SPRINGS AT WATERVIEW
DRAINAGE LETTER
EL PASO COUNTY, COLORADO

July 2019

PCD No. SP-16-005
PCD No. SF-16-017

Channel Model Plan: 100-YR 7/5/2019

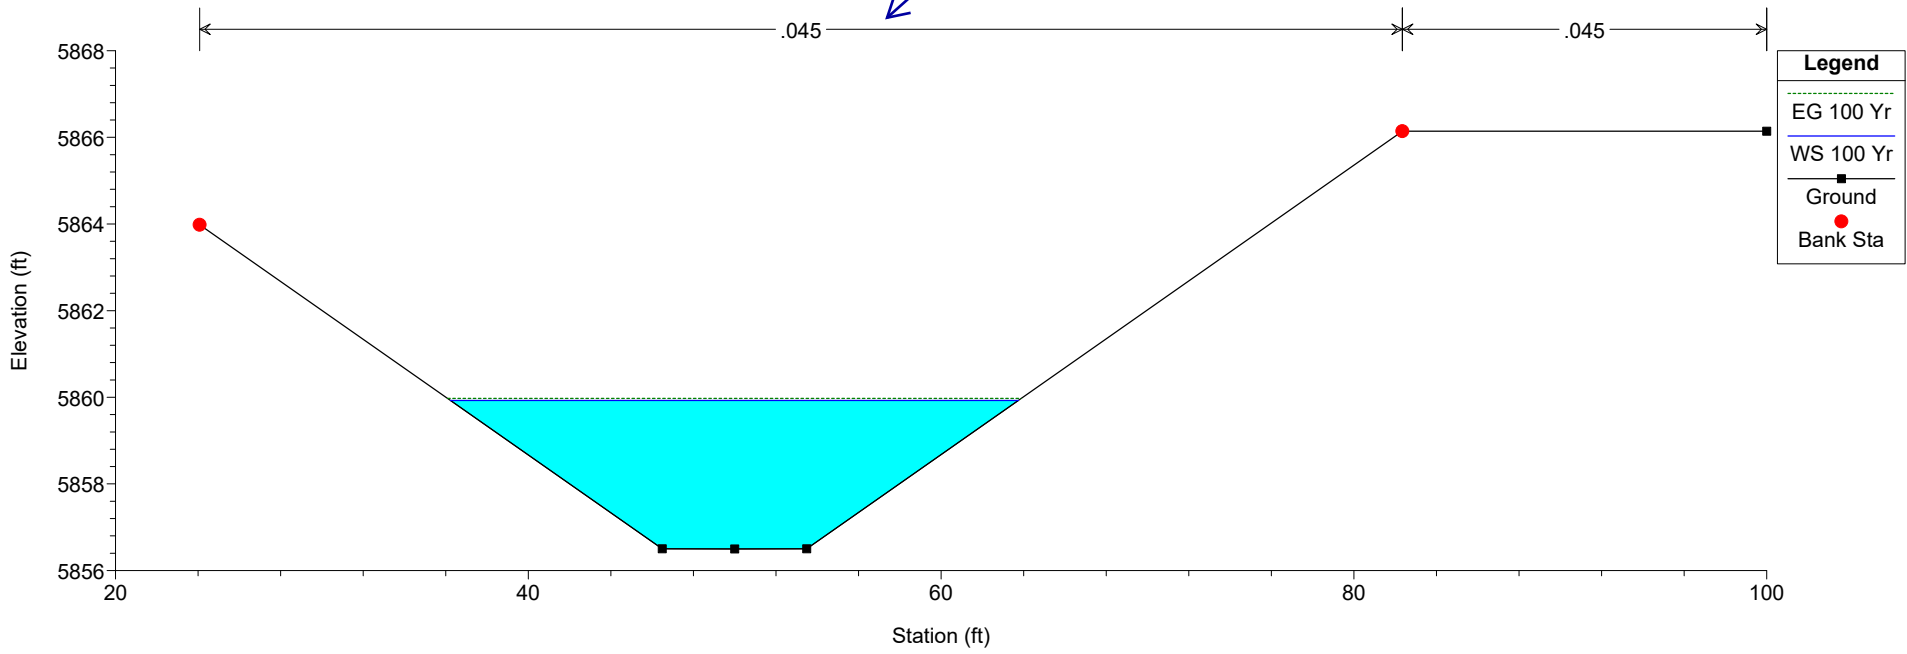
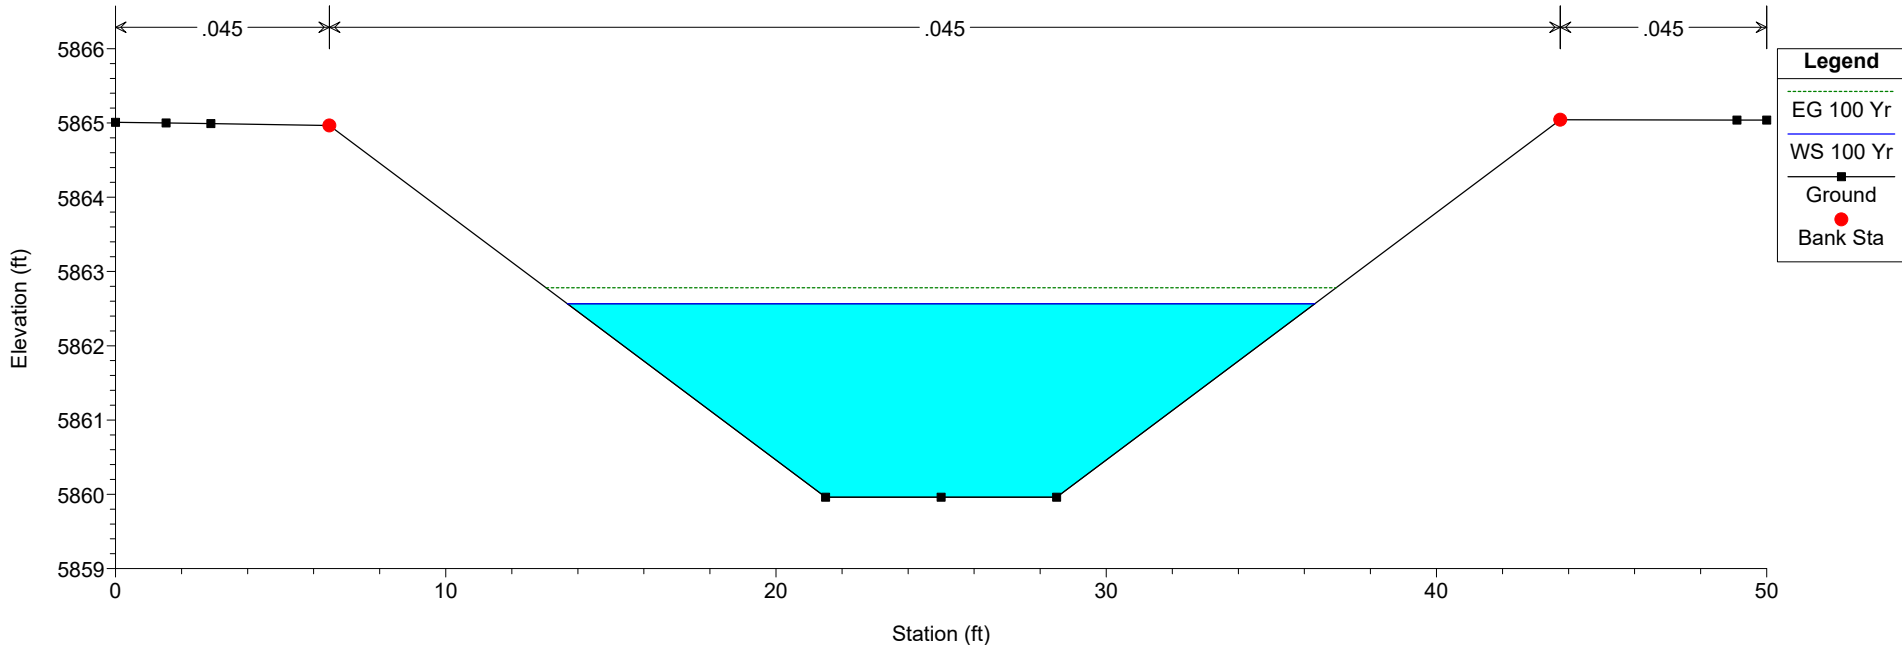
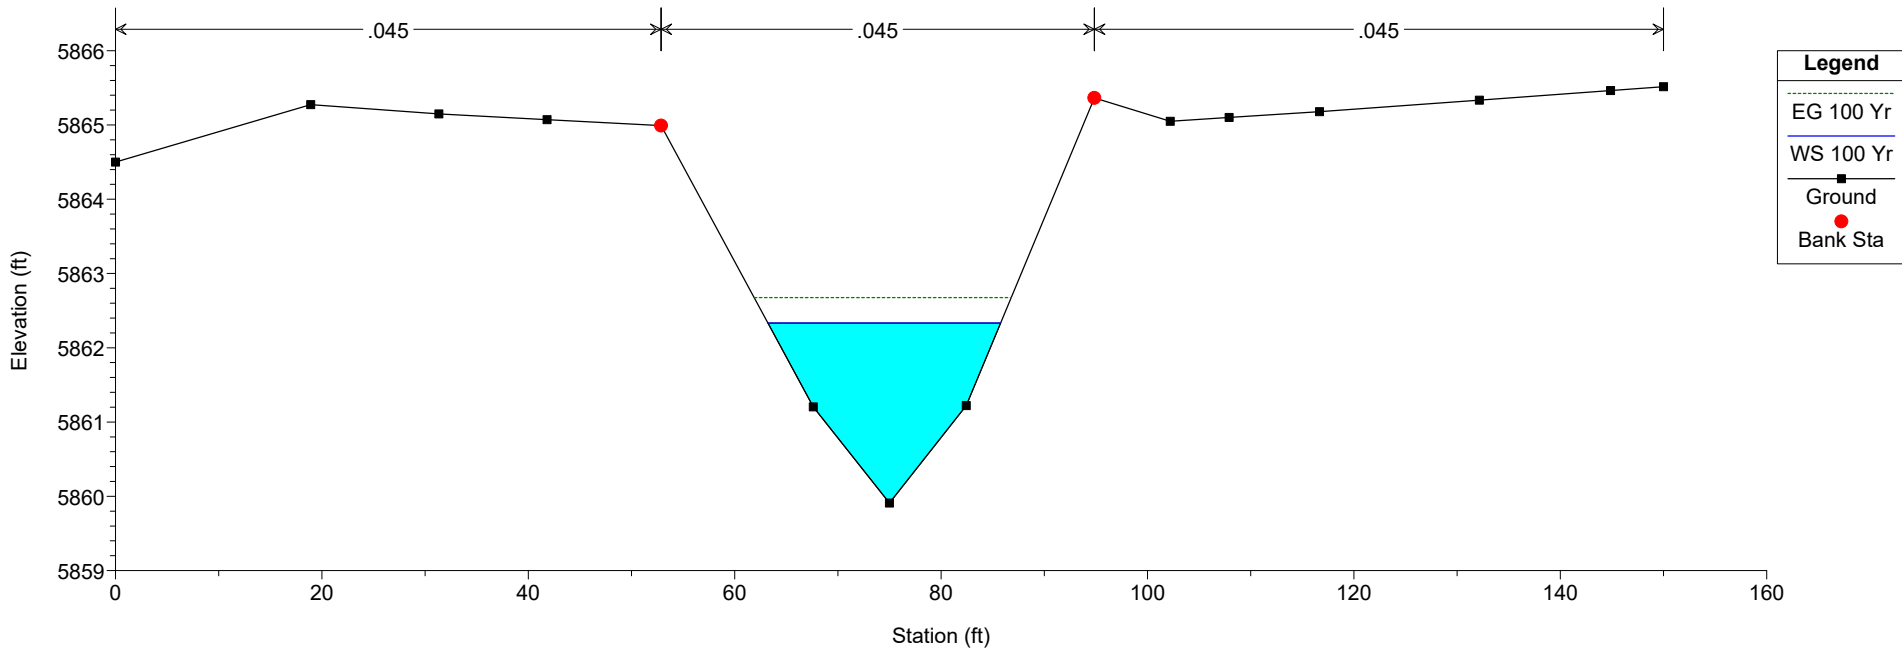
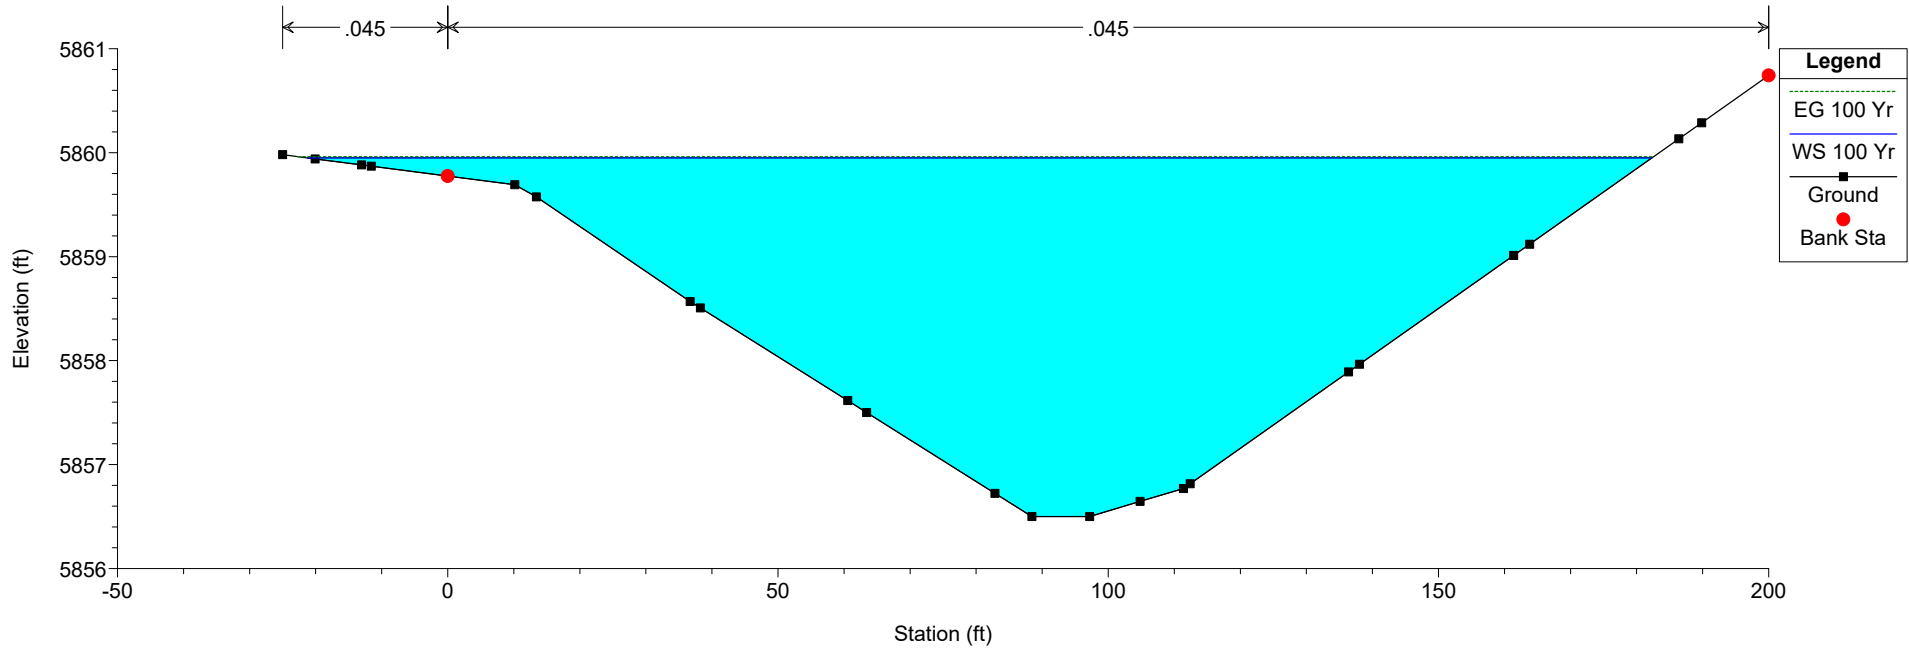
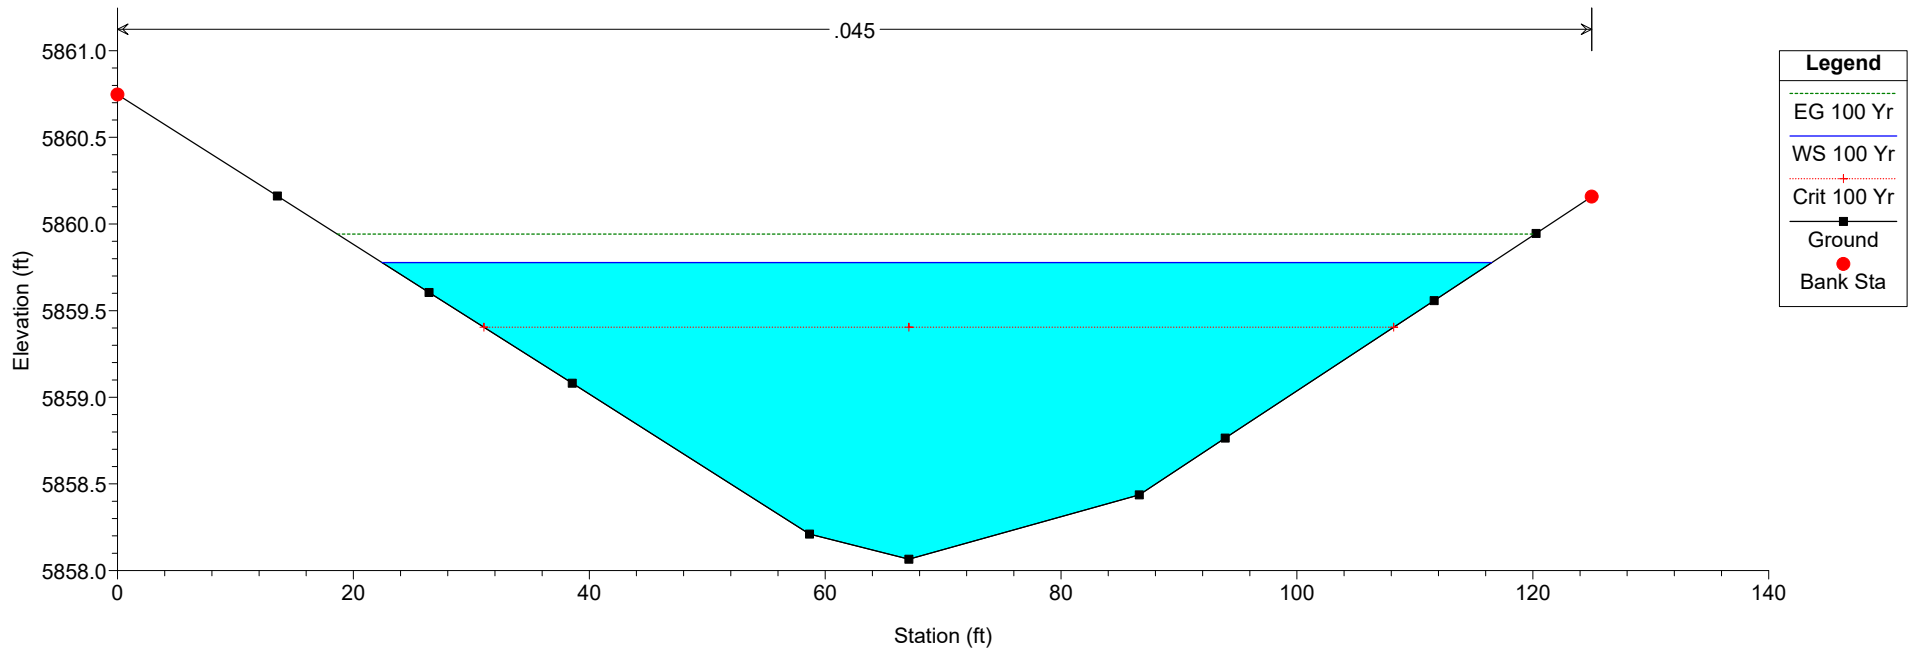
Identify the corresponding reach and station for each cross section.

FIGURE 4

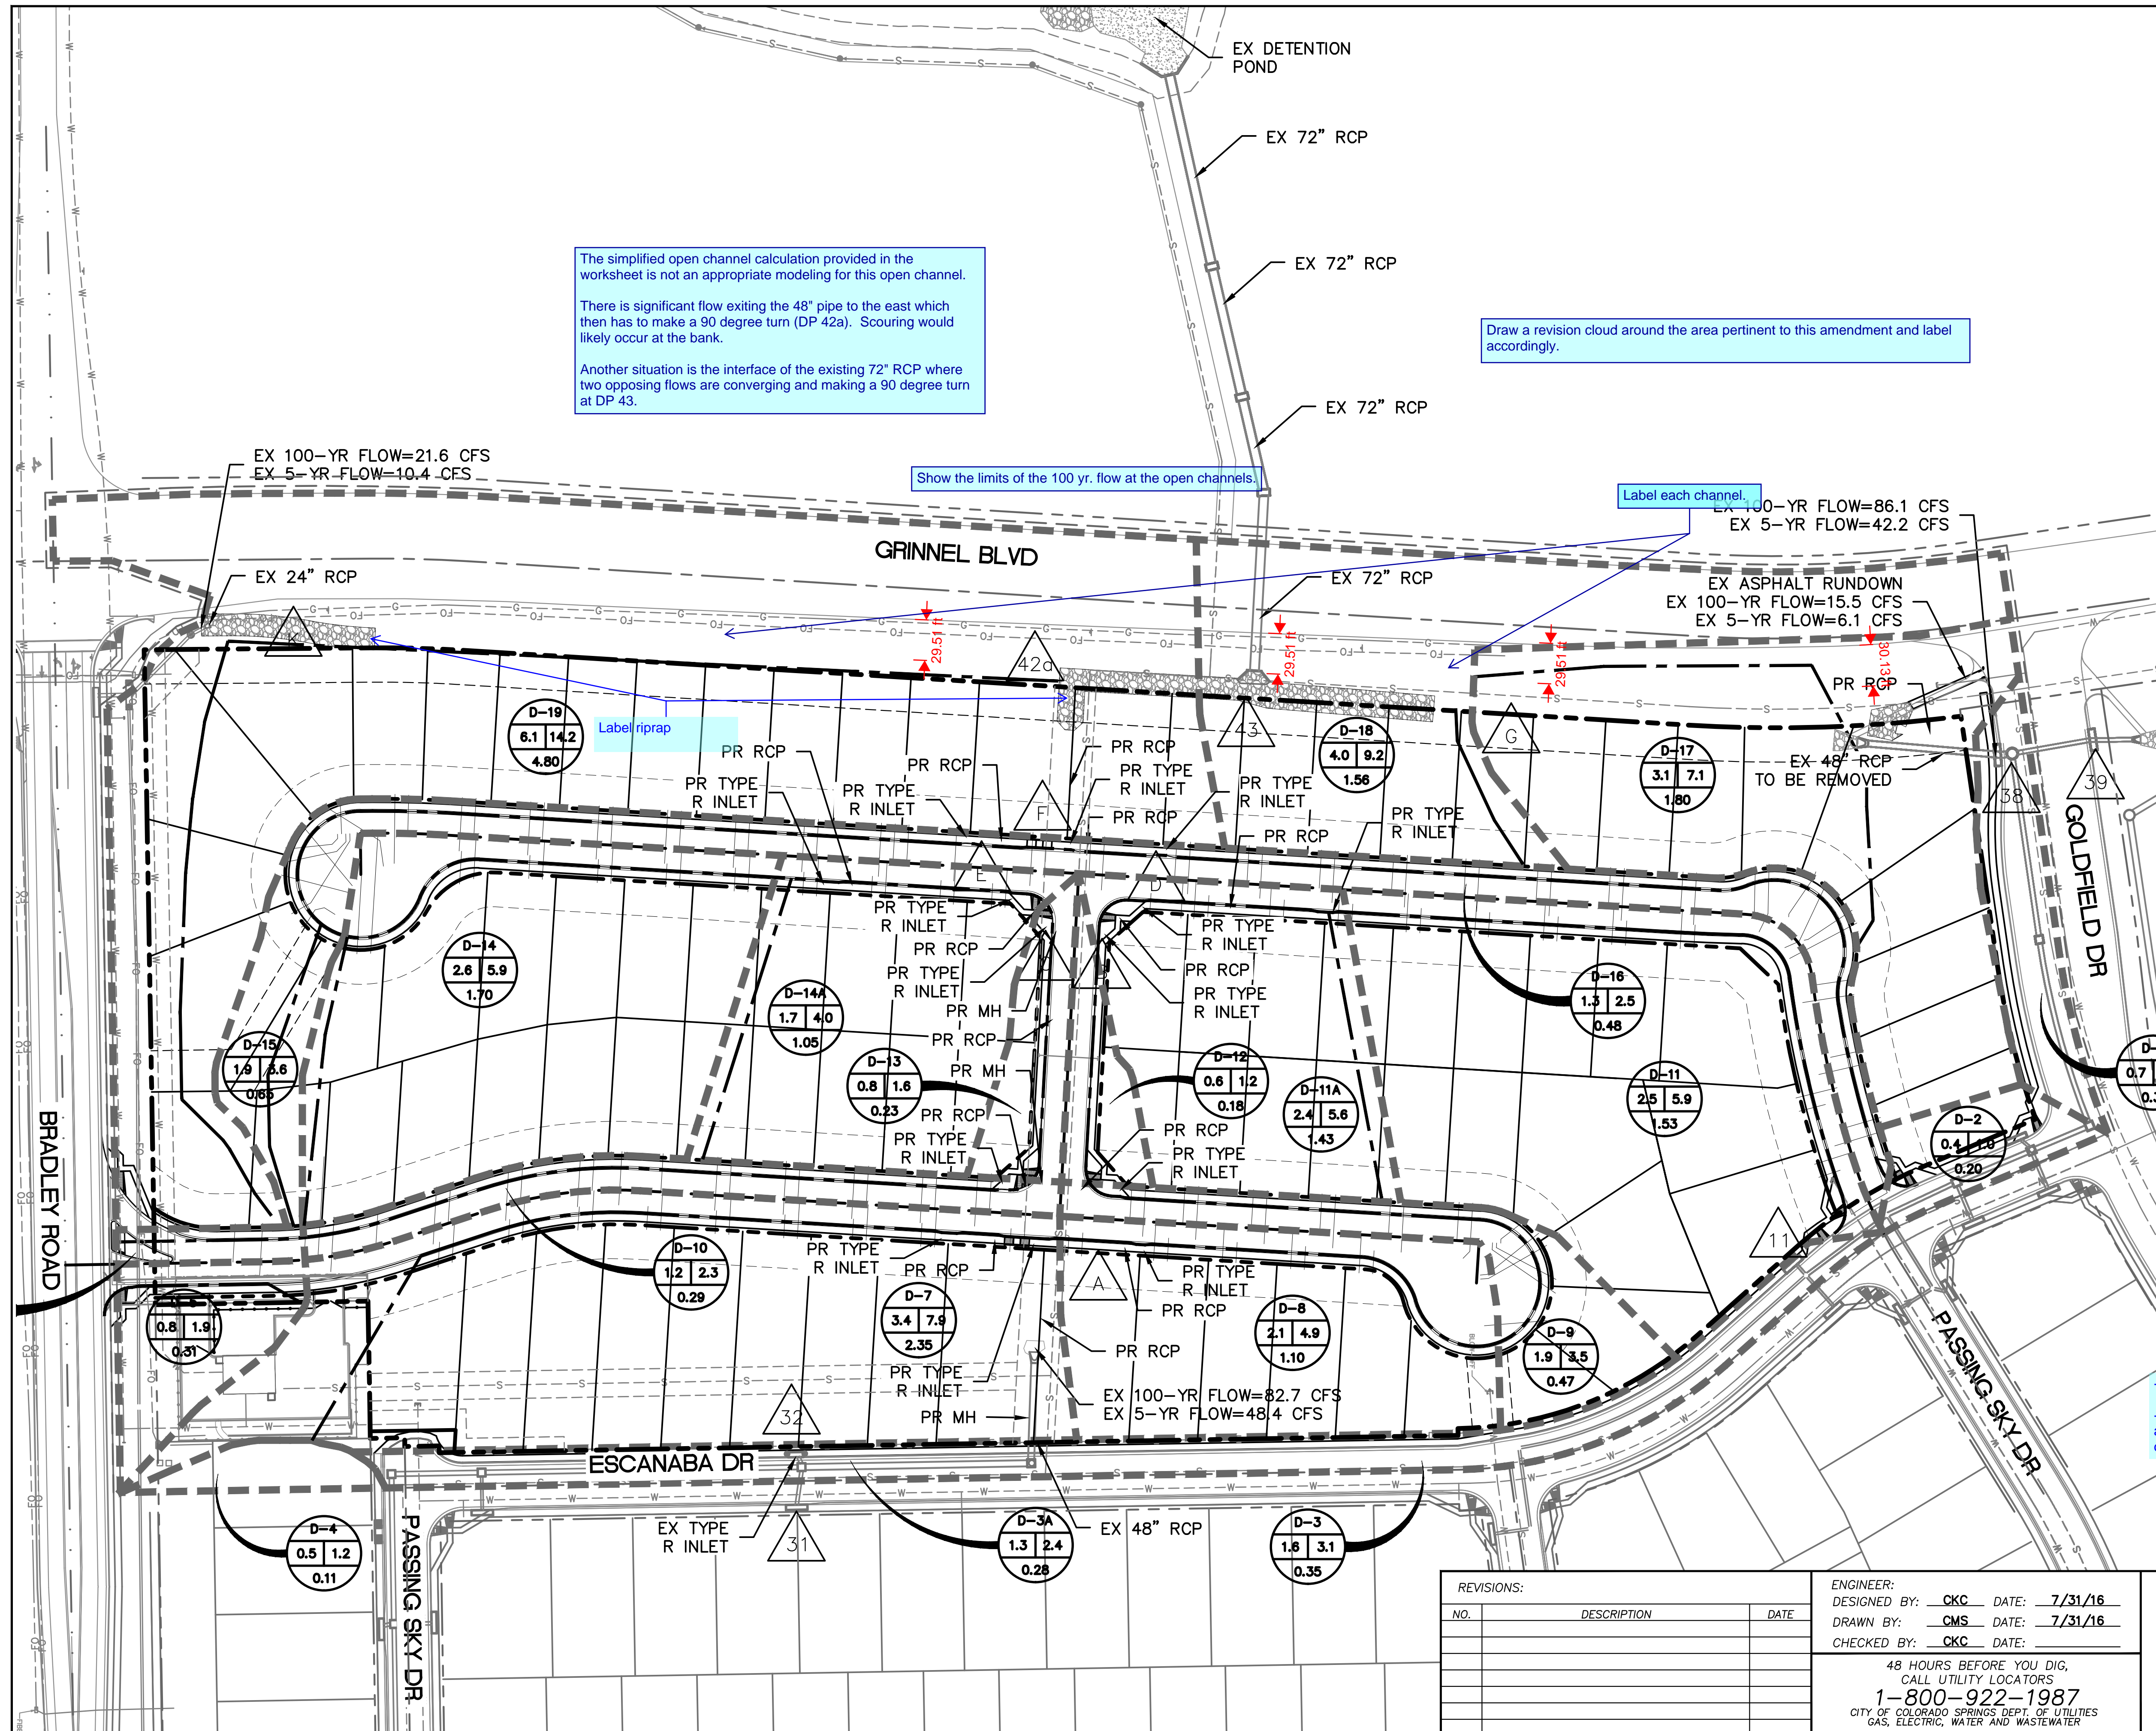
The simplified open channel calculation provided in the worksheet is not an appropriate modeling for this open channel.

There is significant flow exiting the 48" pipe to the east which then has to make a 90 degree turn (DP 42a). Scouring would likely occur at the bank.

Another situation is the interface of the existing 72" RCP where two opposing flows are converging and making a 90 degree turn at DP 43.

Draw a revision cloud around the area pertinent to this amendment and label accordingly.

Show the limits of the 100 yr. flow at the open channels.

Label each channel.

Update to provide the combined flow at the design points.

Add a footnote on the table referencing the approved FDR for detailed calculations. Asterisk any DP that's changed and provide the calculation.

Fix viewport so that basin label is visible.

Show the existing and proposed contours.

Show and label all storm sewers. It appears that they have been turned off/removed.
